UNITED STATES PATENT AND TRADEMARK OFFICE

APPLICATION NO.	FILING DATE	FIRST NAMED INVENTOR	ATTORNEY DOCKET NO.	CONFIRMATION NO.
10/666,387	09/18/2003	Dennis Brandon	28396-6	7522

Office Action Summary

DETAILED ACTION

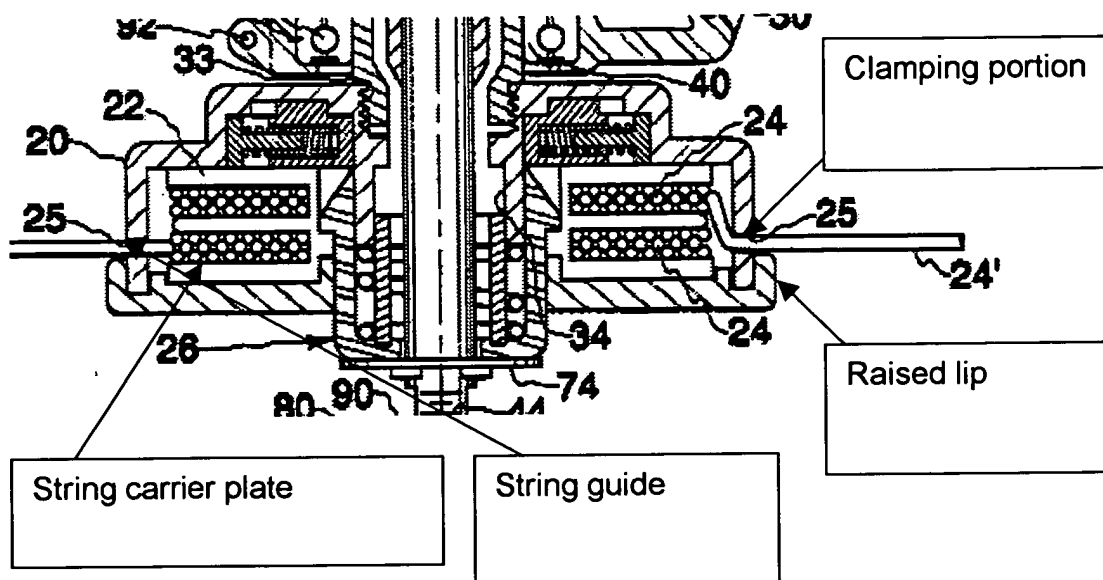
a spindle housing & shaft & a carrier for a cutting element (col. 3, ln. 49-52);

a mow ball rotatably connected to one end of the shaft (ground guide 50, col. 4, ln 64-67, col. 5, ln 1-4);

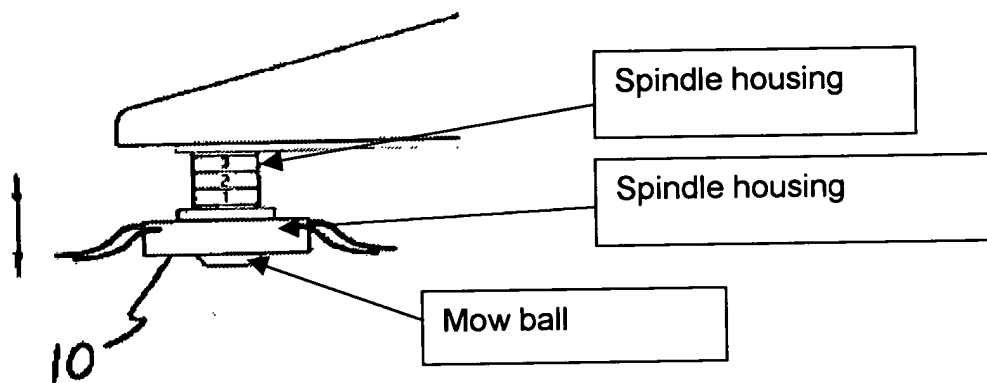
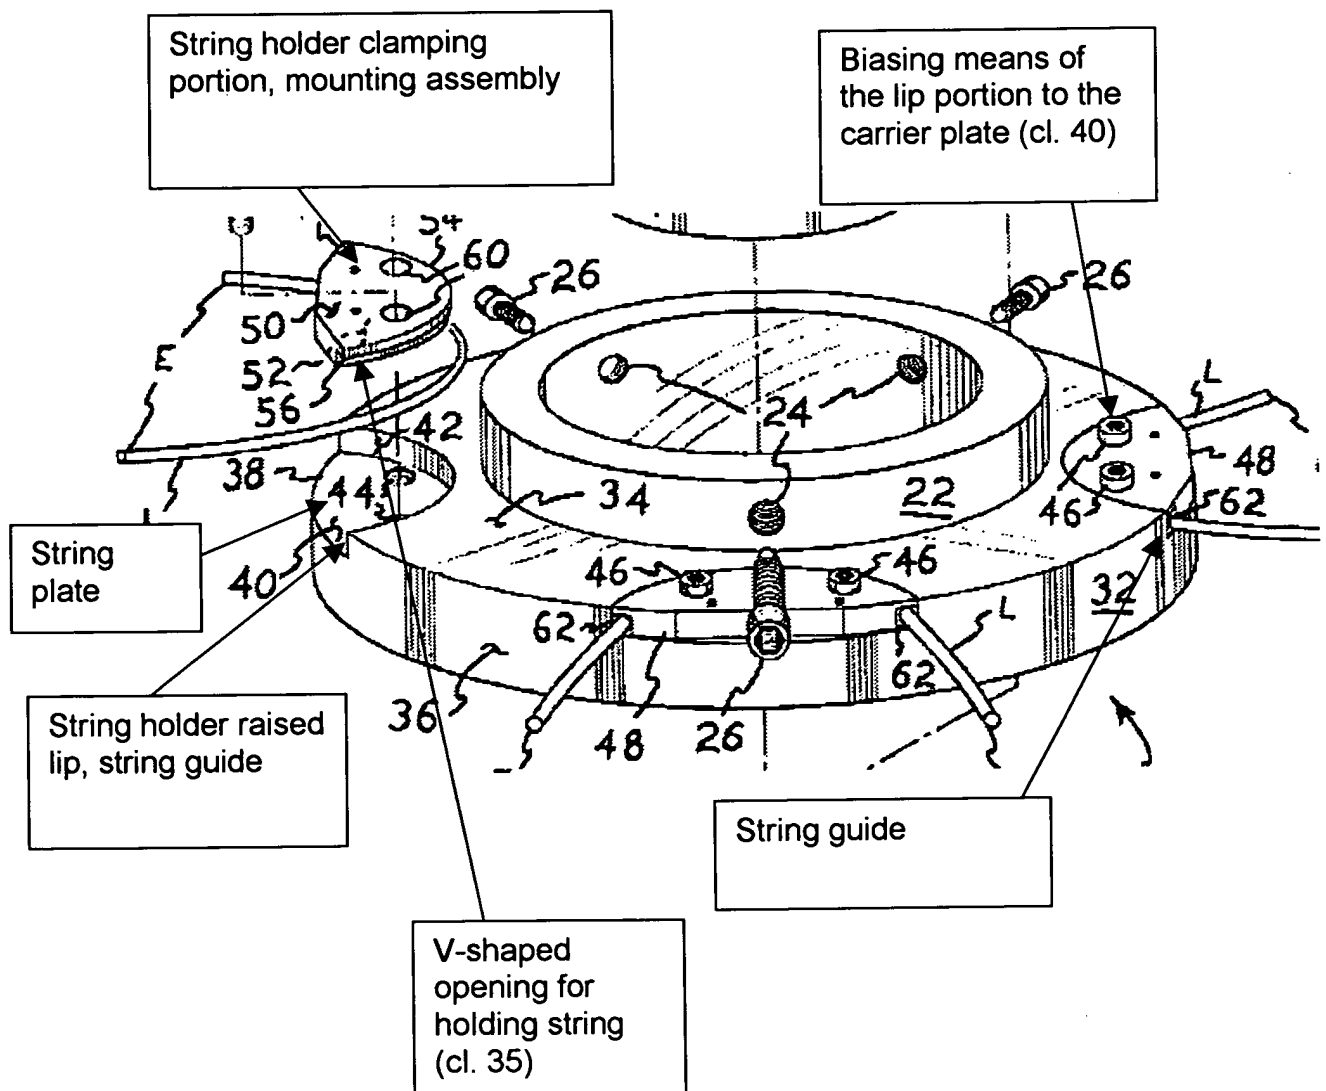
a spindle housing (10);

a shaft or hub (12) rotatably coupled to the spindle housing;

a mow ball is shown at the lower end of the hub, however the rotatable connection between the hub/shaft to the mow ball is not clearly shown;

a string carrier assembly (14) connected to the spindle shaft/hub intermediate the spindle housing and the mow ball (see fig 3);

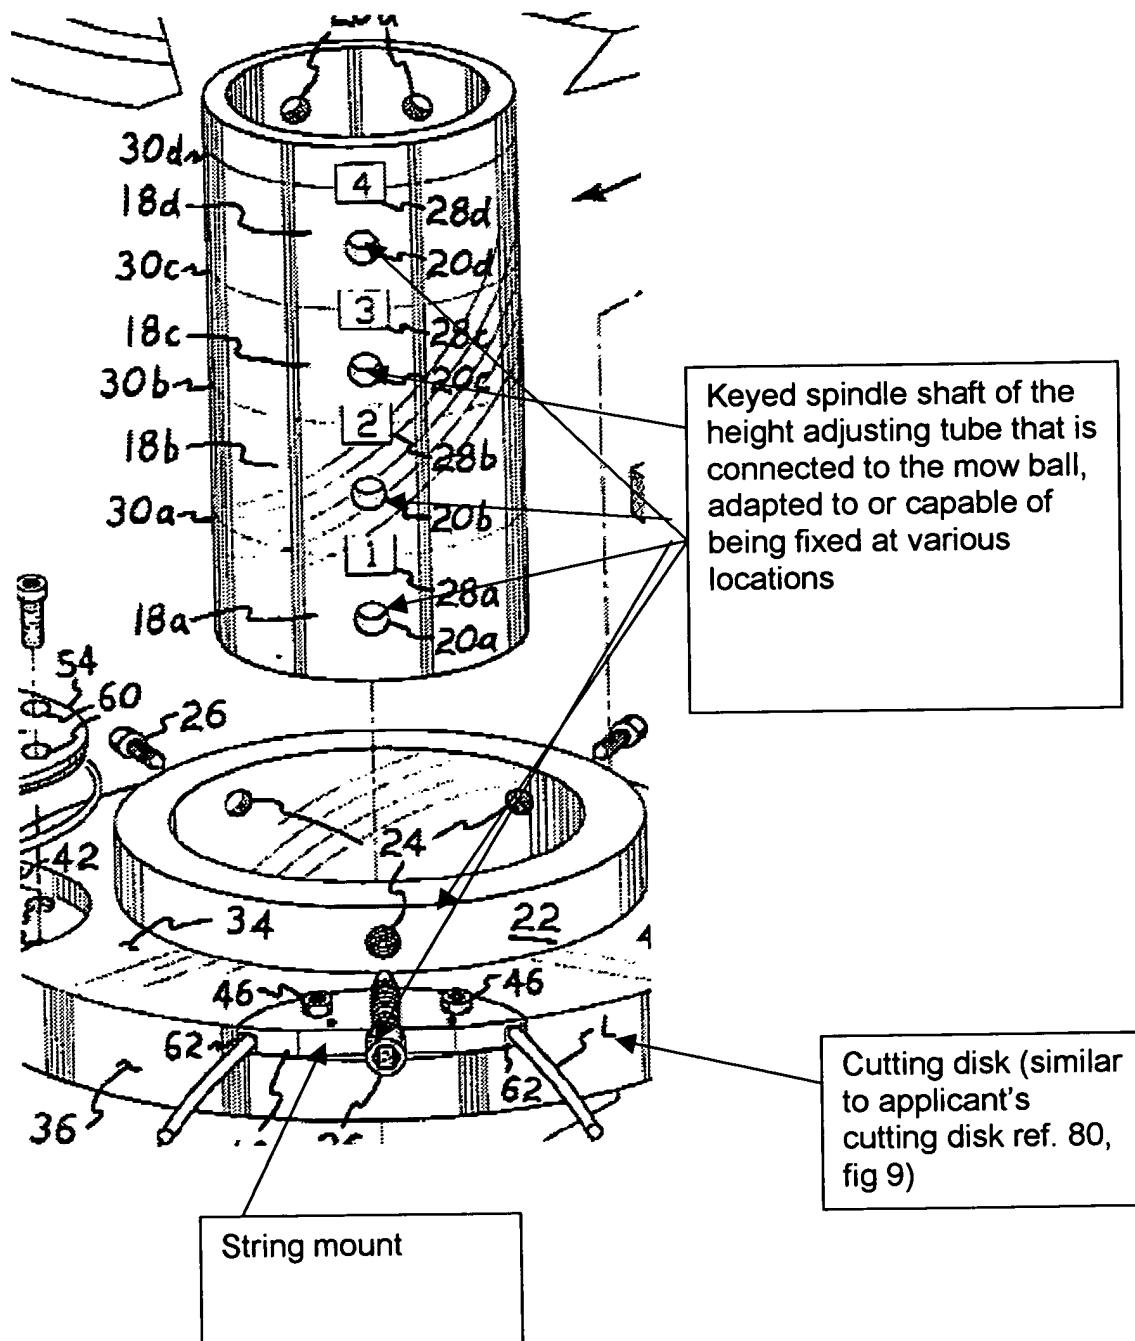
a string carrier plate, string guide, & string holder: raised lip & clamping portion:

the string holder includes a raised lip portion (the upper part of 48) and a clamping portion (56);

the carrier assembly includes a mounting assembly (45) and a carrier plate (32);

the plate includes a string guide (between 56 & 42) and a string holder (48);

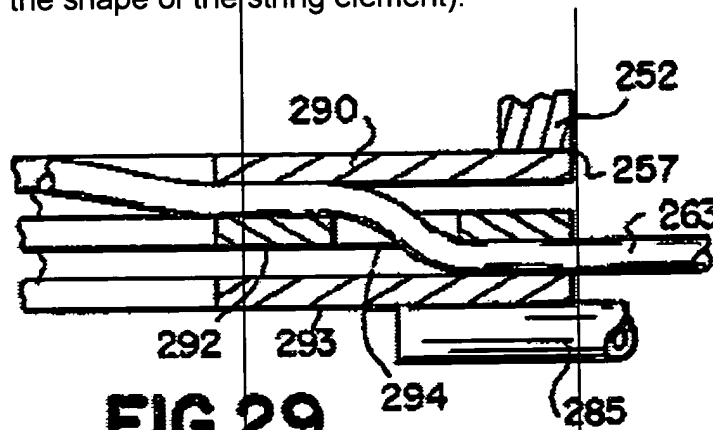
Sweet discloses a spindle housing (generally shown on fig 21, ref 139);

a spindle shaft (154);

a pulley (167) at one end of the shaft (see fig 13);

a mow ball (see the lower part of ref. 251, where the actual ball shape is shown) rotatably connected to a second end of the spindle shaft (see fig 22, at the second end of the shaft at ref. 158);

a string carrier plate (292) connected to the spindle shaft intermediate the spindle housing and the mow ball (see fig 21);
